**TOPIC: AUGER INTERFERENCE**

**AFFECTED: FERRIS SNOW BLOWERS**

Figure 1

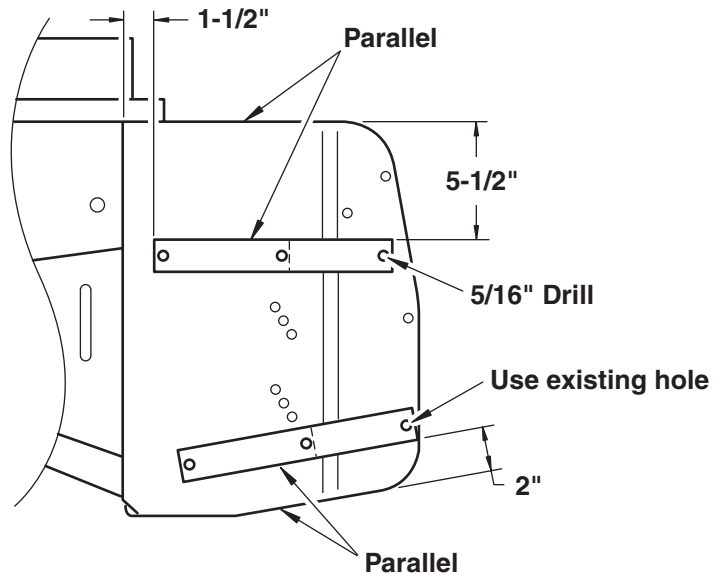
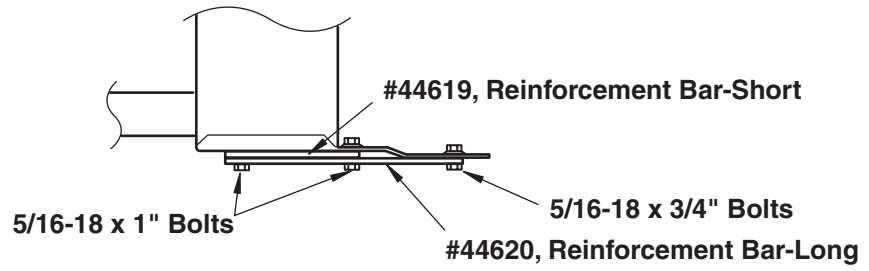
Fiel reports have indicated that the end panels of the snow blowers are bending inward causing interference between the auger chain guard and the auger, sprocket and chain. To rectify this problem, the following parts can be ordered to reinforce the end panels.

1. Remove the auger chain guard.
2. Clamp the reinforcement bars in place on the outside of the end panels (see Figure 1).
3. Using the reinforcement bars as a template, drill 5/16" holes in the end panels and assemble with the specified bolts (see Figure 1).
4. Check the clearance between the auger and the end panel of the left-hand side of the snow blower (from the operator's position). (See Figure 2) There should be 5/8" clearance to prevent any interference between the auger and nuts assembled in Step #3. If any adjustment is necessary, use a hammer or crescent wrench to bend the end of the auger.
